Technical Journal

Seat hard to push back, second row seat (7 seater)

REF NO: TJ 32025.1.0	ISSUING DEPARTMENT: Technical Service	CAR MARKET: United States and Canada	
PARTNER: 3 US 7510 Volvo Car USA		ISSUE DATE: 2016-11-21	STATUS DATE: 2016-11-28
FUNC GROUP: 8531	FUNC DESC: Rear seat, complete	Page 1 of 6

Second row in 7-seater: Hard to fold back backrest

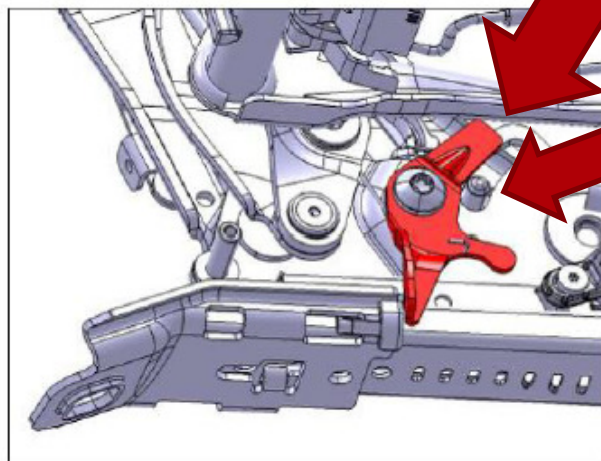
- Outer seat in Second row is hard to move back after entrance to third row.
- Backrest folds back too early (before seat is slided back).

Stopping edge of rebound bracket wear against the stop screw. This wear prevents it from releasing.

- Replace the rebound bracket.
- New concept "knee lever" to be introduced.

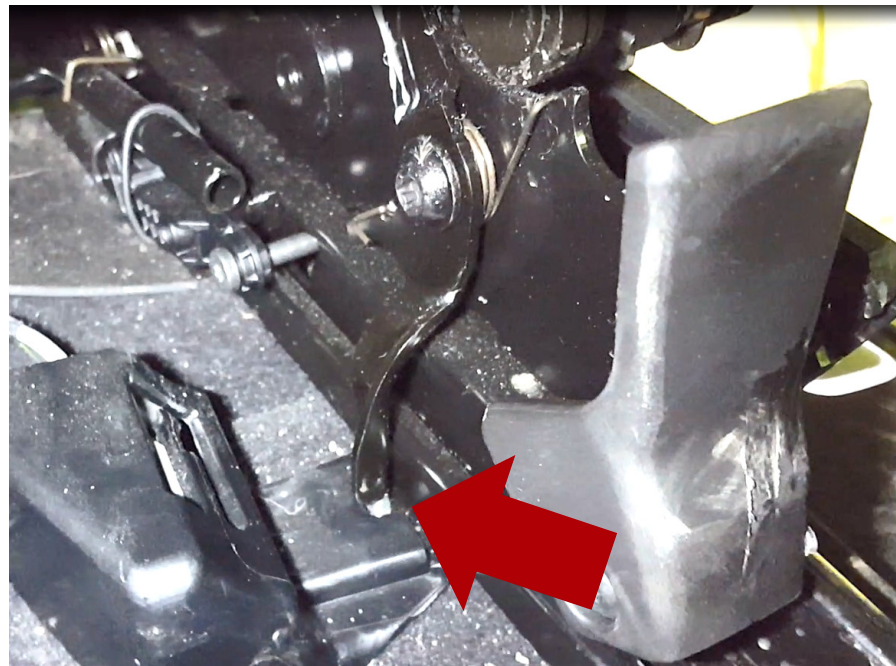
Outer seat in second row is hard to move back after entrance to third row.

Lower part of rebound bracket sticks on screw head.

- Grind down the screw head.
- New concept with lower screw head.

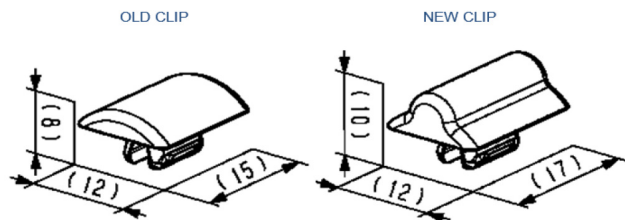
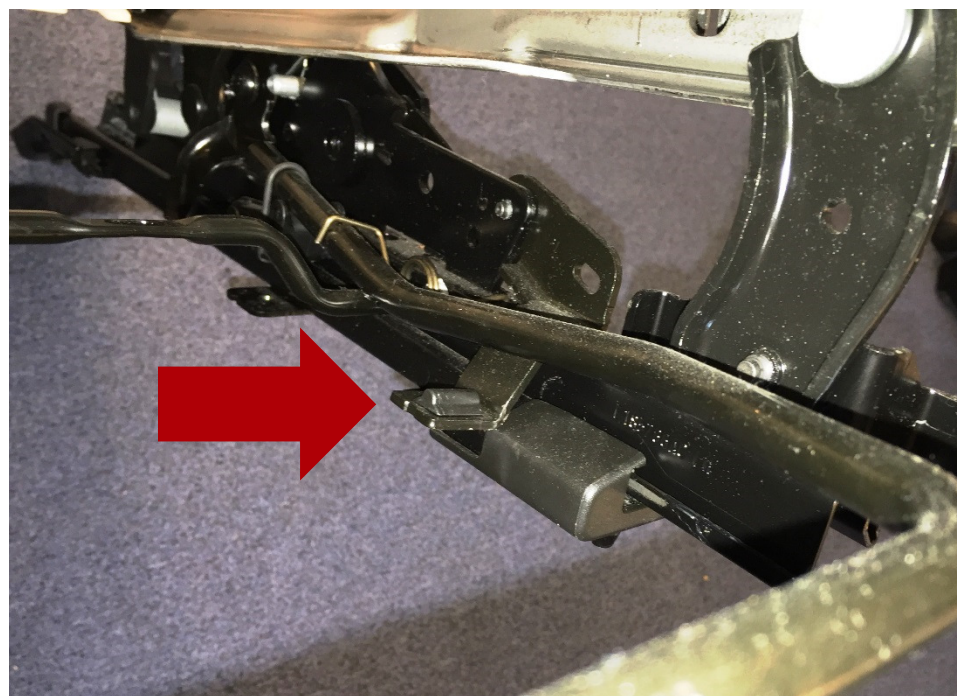
Outer seat in second row is hard to move or makes rattling noise over the rails.

Plastic stoppers for adjustment lever forward/backward too low.

Replace stoppers to new, higher model.
No p/n change, use the VIDA part number.

Issue: Second Row outer seat, 7 seater

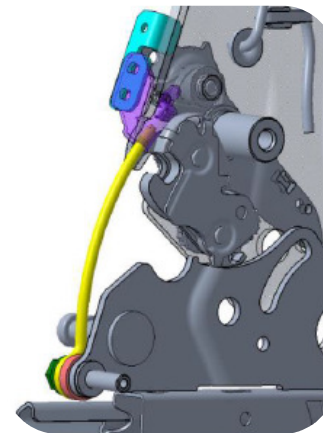
Gap closer can get stuck and damaged when back rest is folded back.
To avoid on current cars: Always start from normal position when seat are supposed to be flat folded. (Do not start from easy entry position.)

Solution step 1 Current Gap closer will be redesigned.

Solution step 2 New concept under development.
